## **Base Isolation Addendum:**

### **Pricing Package Only - Not for Construction**

**4-18-2011**

## **BASE ISOLATION ADDENDUM PACKAGE 4-18-2011: FOR PRICING ONLY - NOT FOR CONSTRUCTION**

FOUNDATION PLAN  
BIS-22

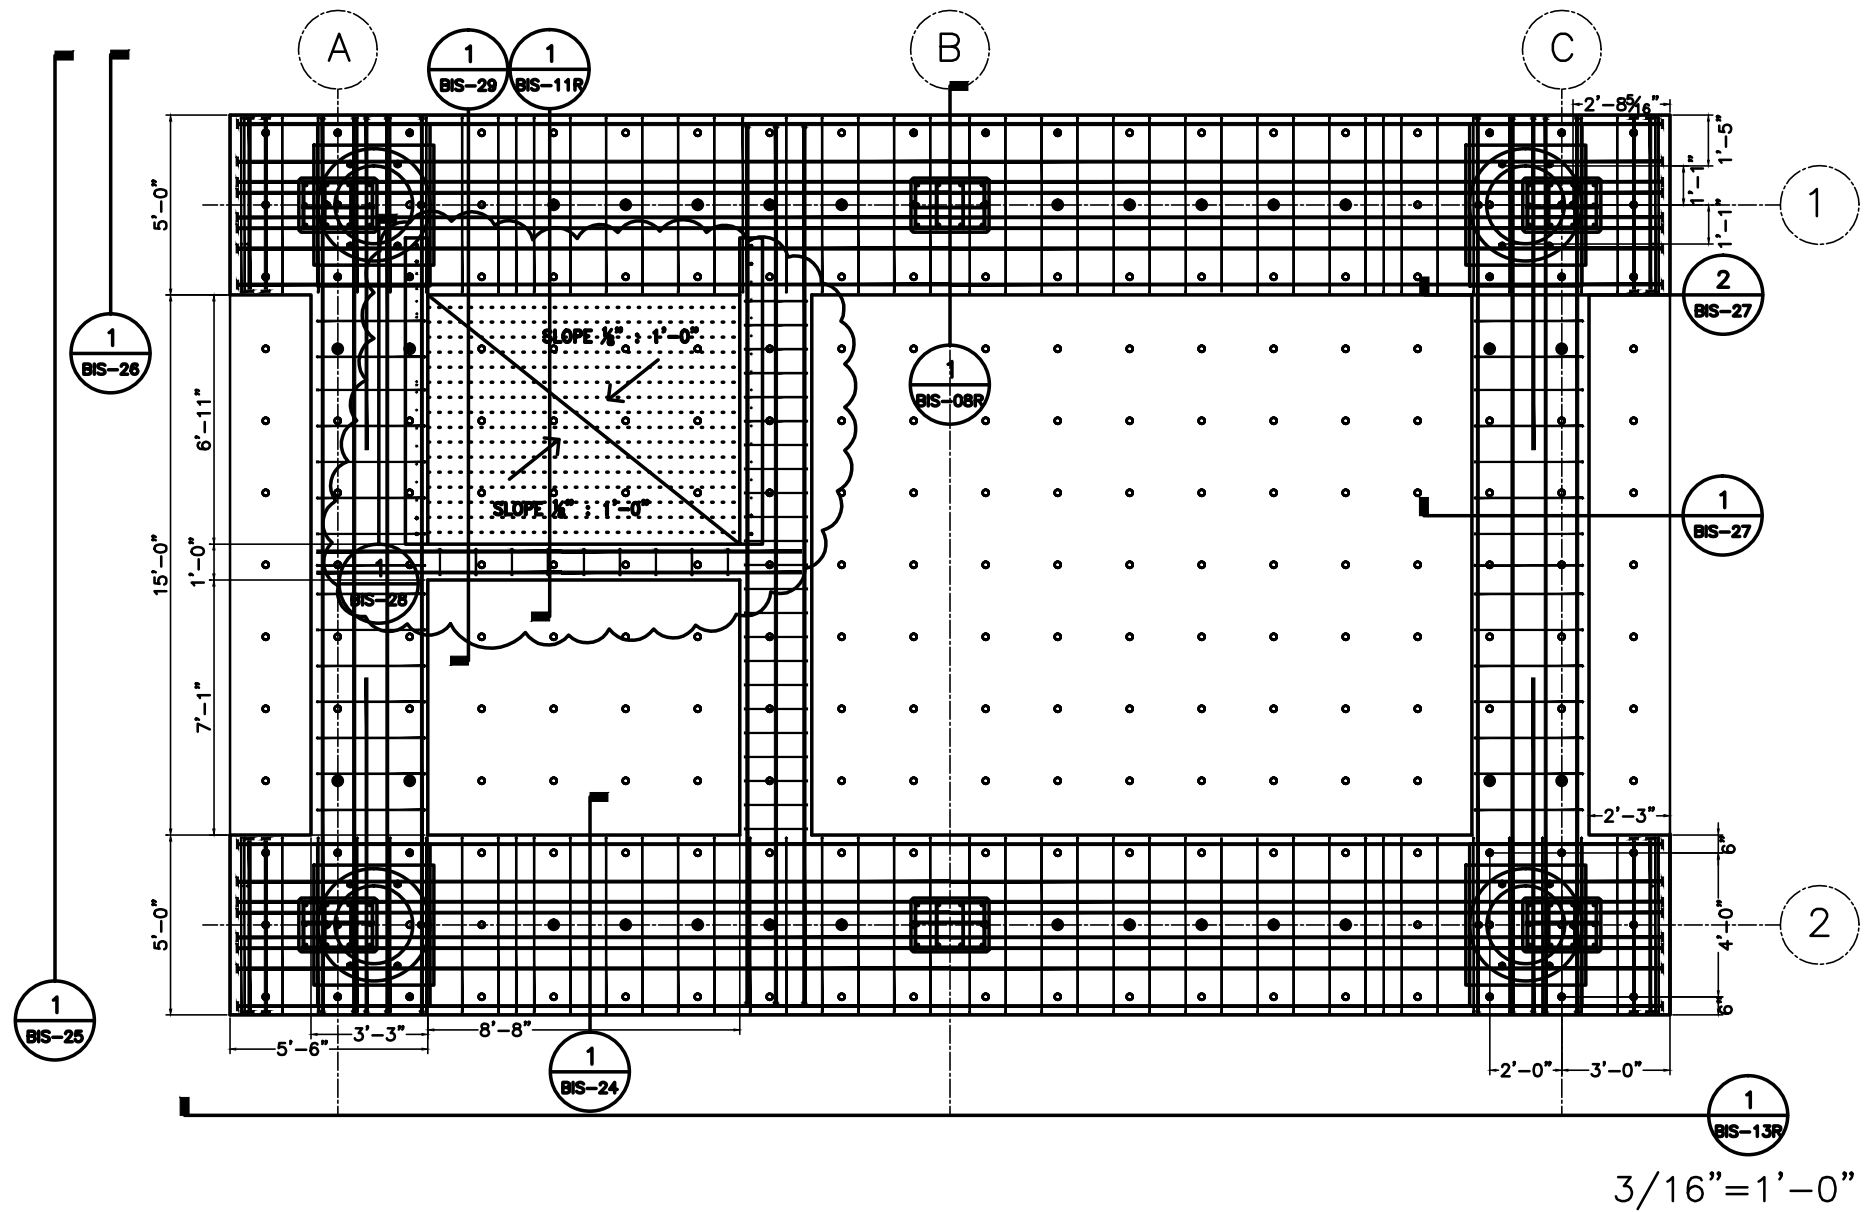
- 3) Elevator walls changed: new dimensions and locations
  - a. Note: the dimension and location change will be changed on all levels
  - b. Wall reinforcement now shown in plan view (see BIS-22)

- d. Sleeve dimensions changed and thread size/length specified
- 9) Slope added to elevator pit for drainage (see BIS-22)
- 10) Reinforcement in transverse beam changed as seen on BIS-27 and BIS-25

- e. #4 ties spaced at 12" o.c. instead of 8" o.c. (as seen on BIS-22 and BIS-25)
  - f. Chamfer increased to 2 1/2"
- 11) Reinforcement in longitudinal beam changed as seen on BIS-13R, BIS-08R, BIS-24, etc

# BIS-08R

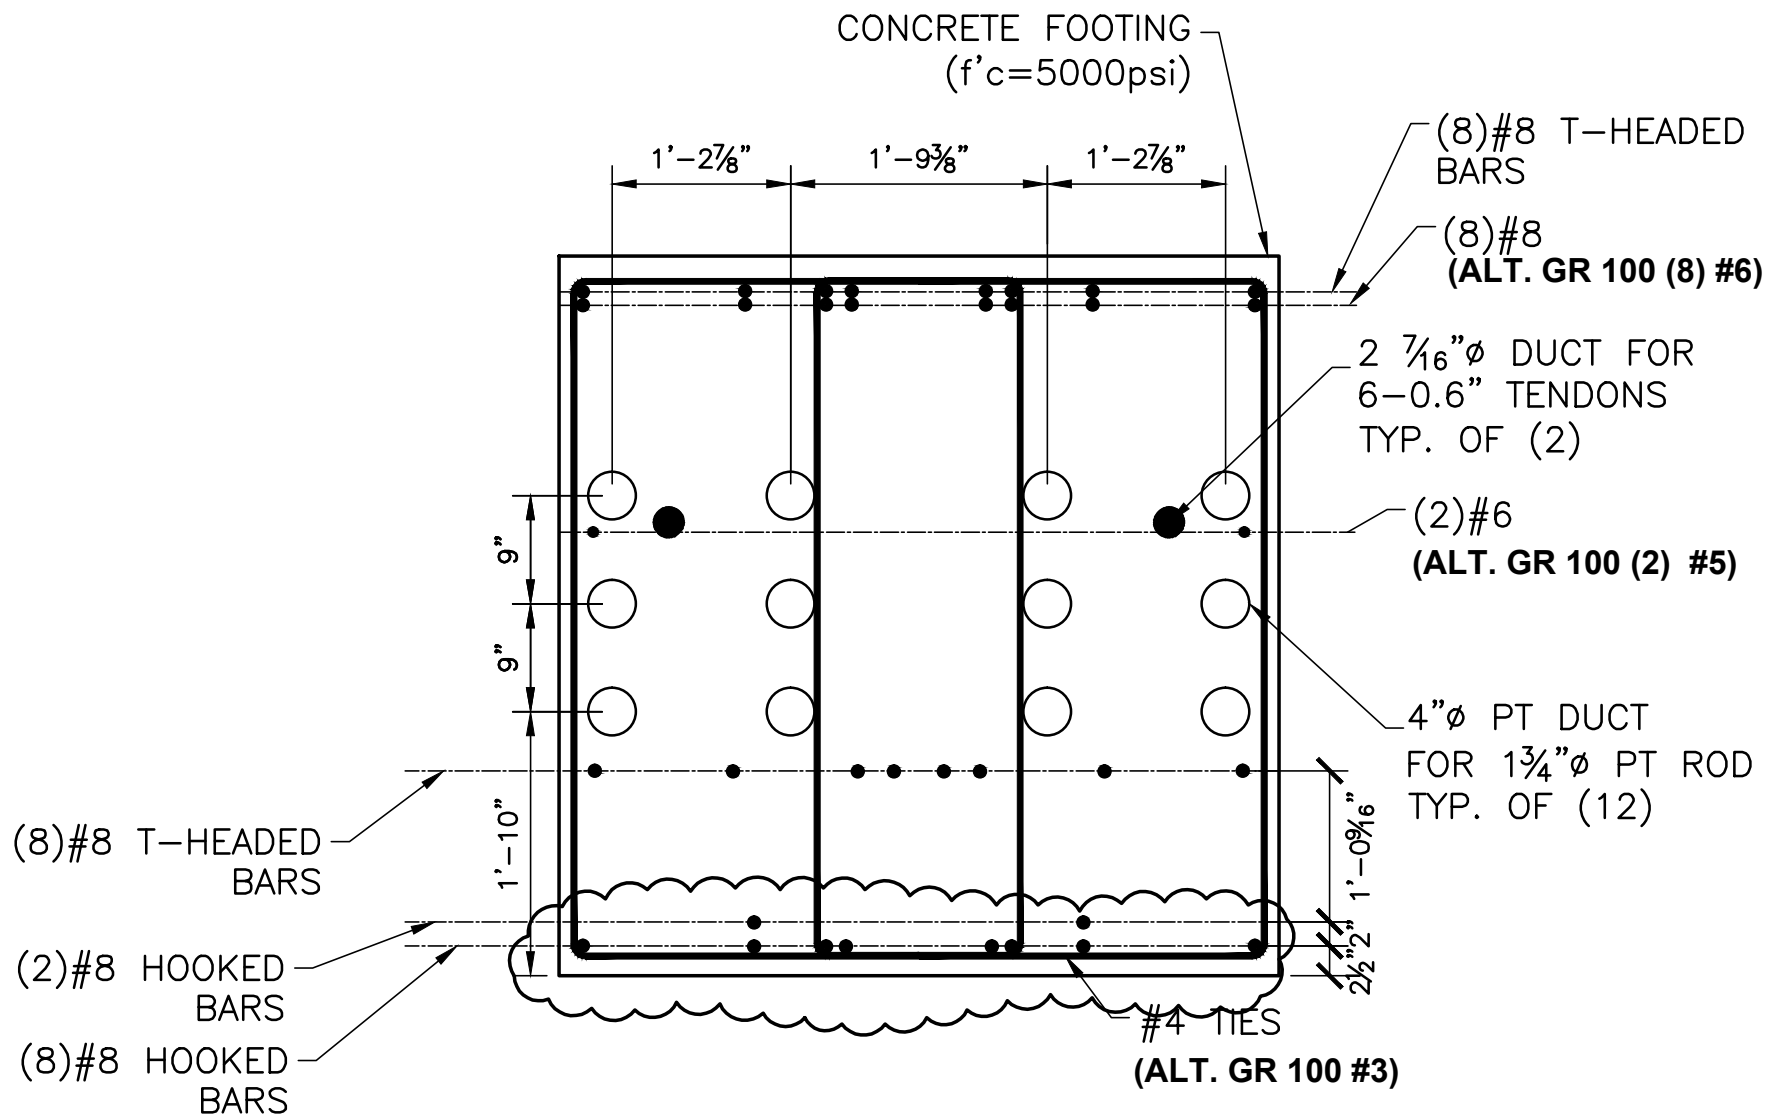
- a. In 5' cross section
    - i. 8#8 removed from top reinforcement
    - ii. Bottom reinforcement changed from 2 layers of 8#8 hooked bars to 1 layer of 8#8 hooked bars and 1 layer of 2#8 hooked bars

- b. In 3'-10" cross section
    - i. 8#8 removed from top reinforcement
    - ii. 8#8 removed from bottom reinforcement

FOUNDATION DETAIL  
BIS-25

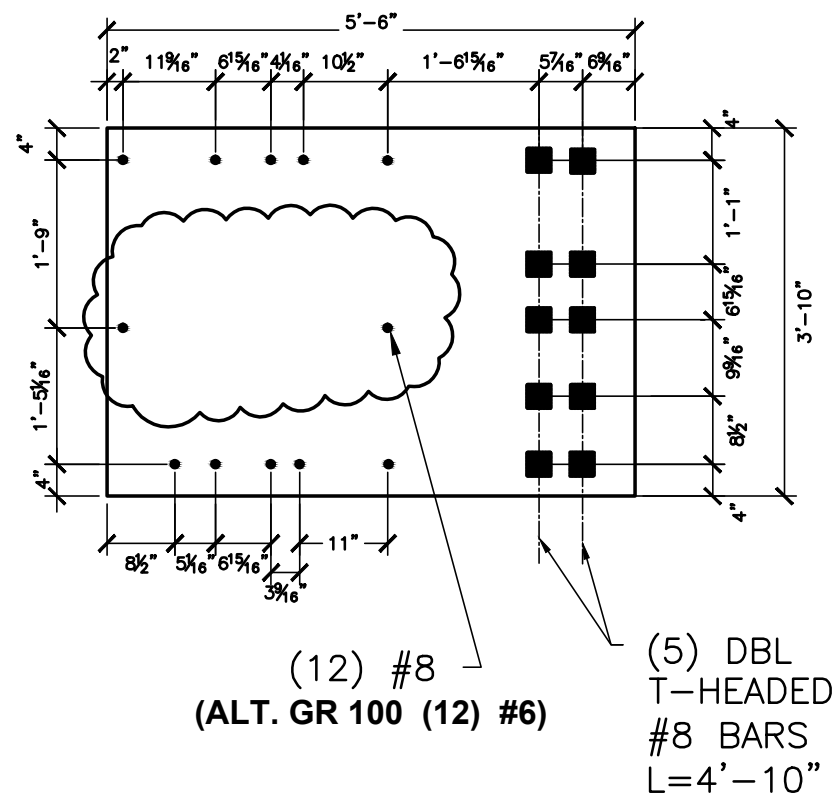
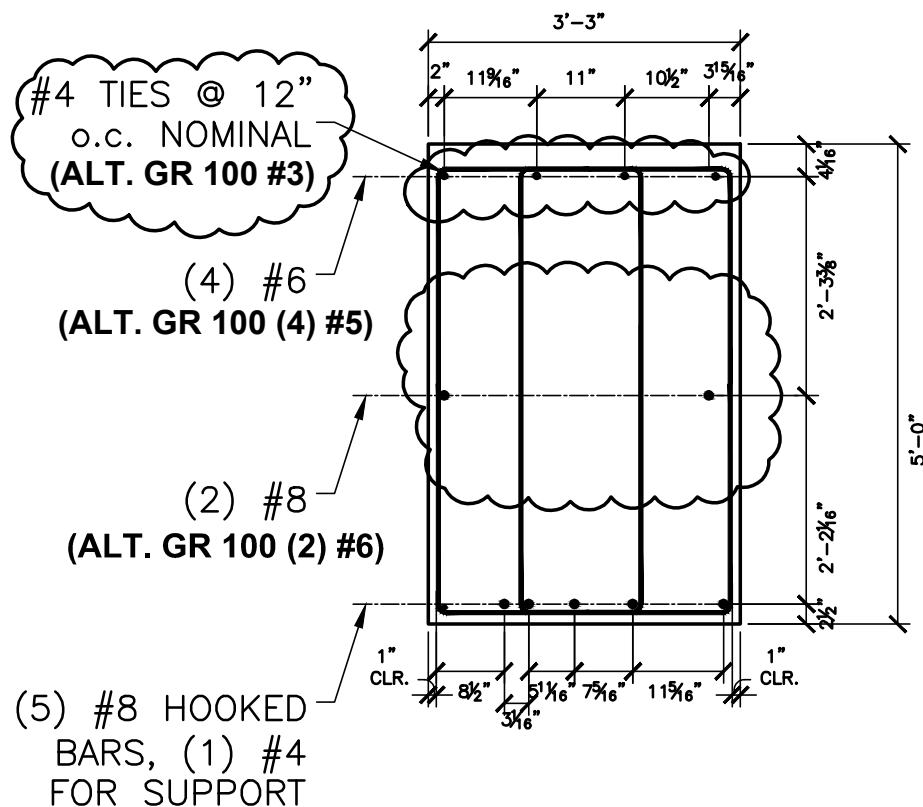
- c. Vertical rebar from wall shown embedded into transverse foundation beam along gridline A (see BIS-25)
- 4) 0.25" of hydrostone added beneath lower plates to account for isolators compressing and uneven areas on shake table

- a. One set of stirrups removed
  - b. 2#8 removed from 5' cross section
  - c. Top reinforcement in 5' cross section changed from 4#8 to 4#6
  - d. 4#8 removed in 3'-10" cross section

FOUNDATION LEVEL WALL DETAIL  
BIS-28

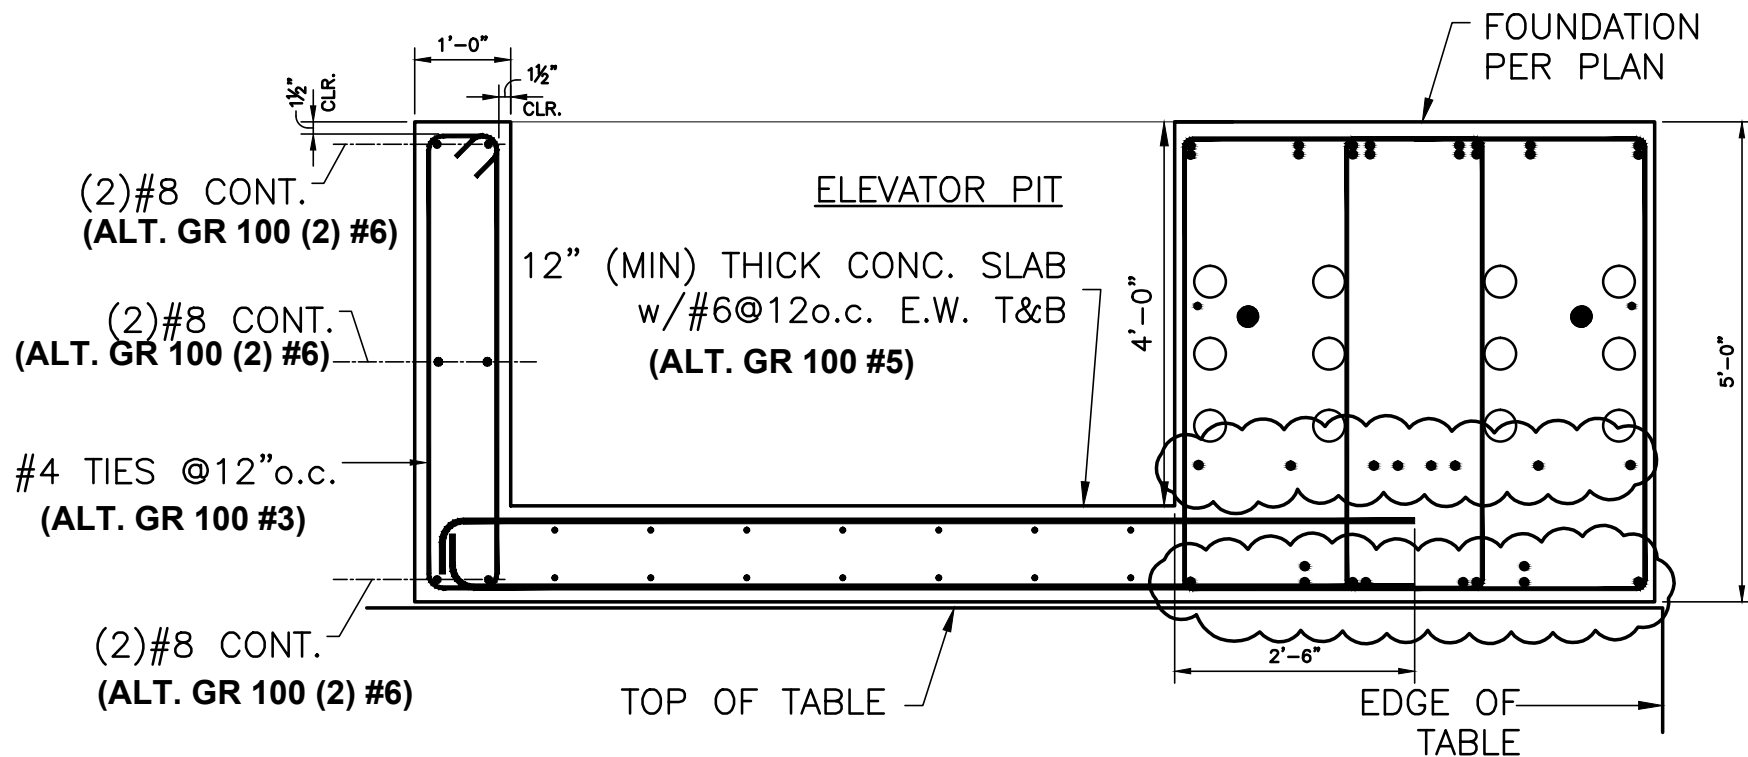
- 1) 1'x5' beam in EW direction removed (detail for this beam originally on BIS-28 also removed)
- 2) BIS-28 completely different detail: now shows elevator wall on foundation level (not typical for all walls) which requires a cut out for jacking.

SEISMIC STOP DETAIL  
BIS-31

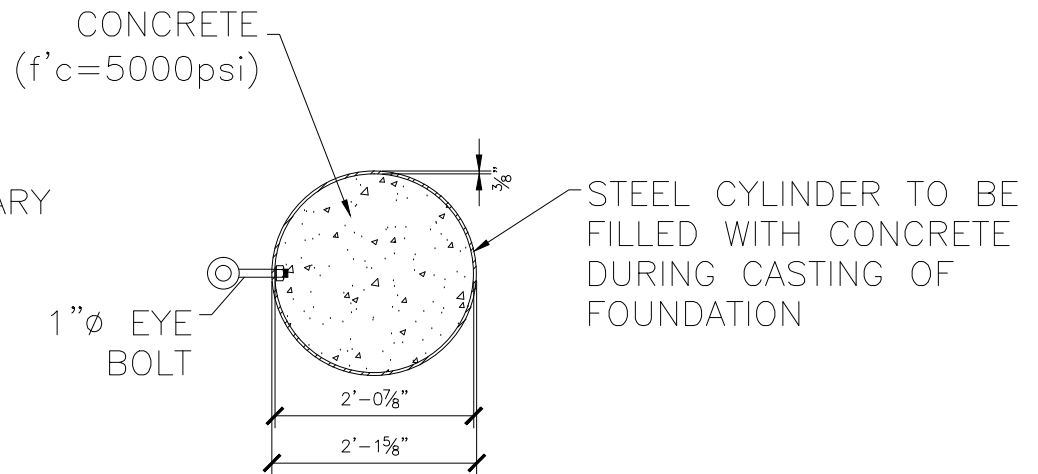
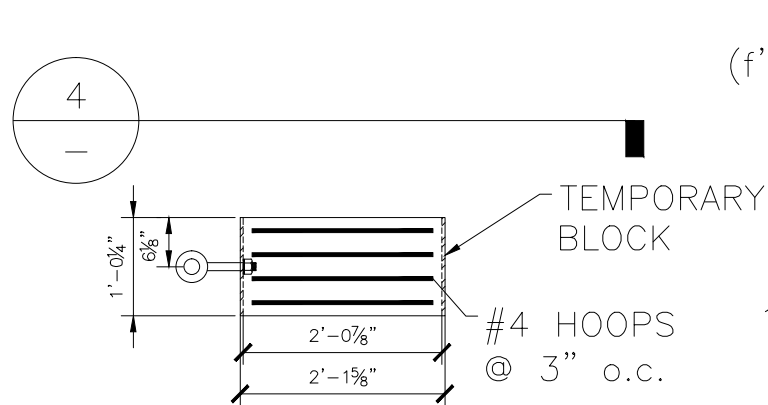
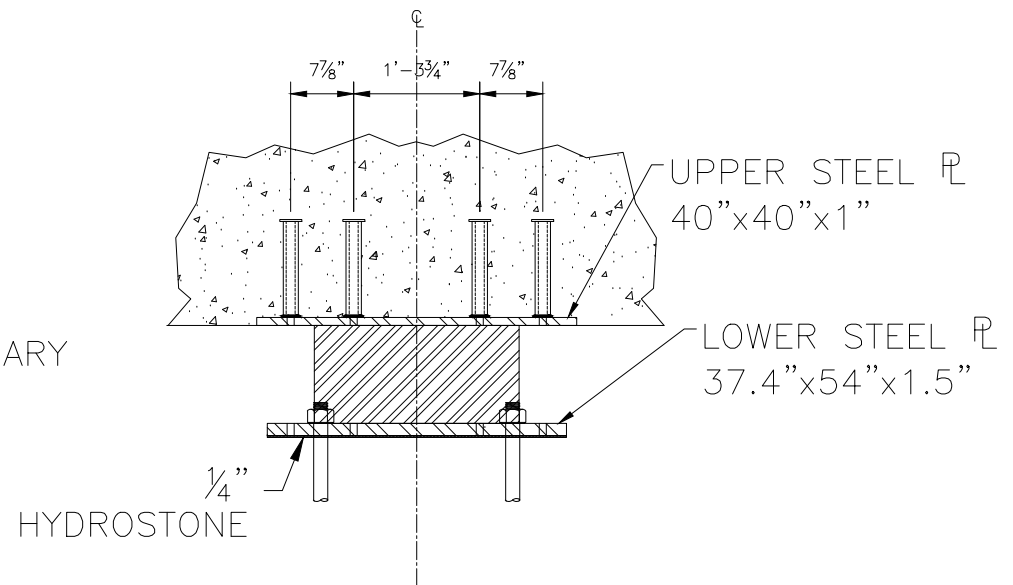
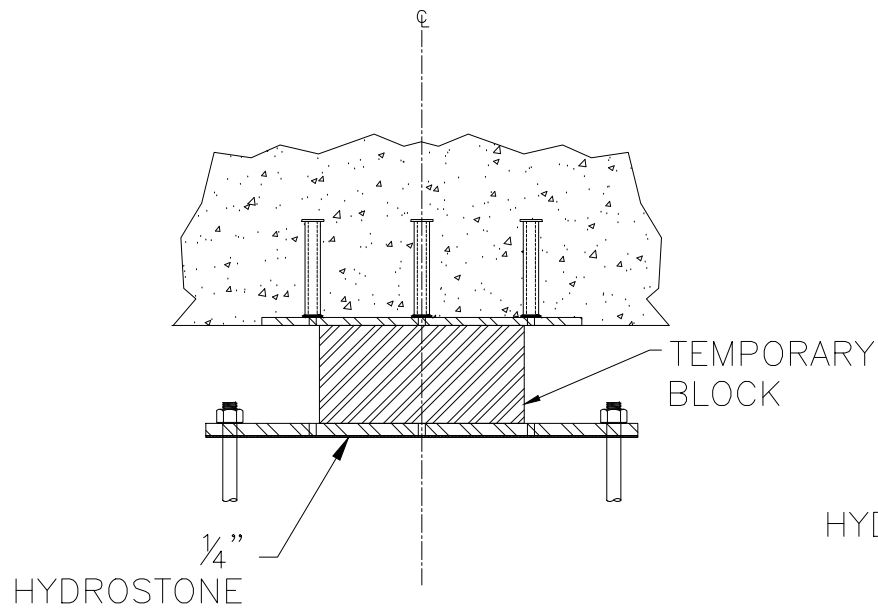
- 5) On BIS-31 28 PT locations for fixed base called out (not 24 as previously stated)
- 6) All details are shown in construction configuration instead of base-isolation testing configuration
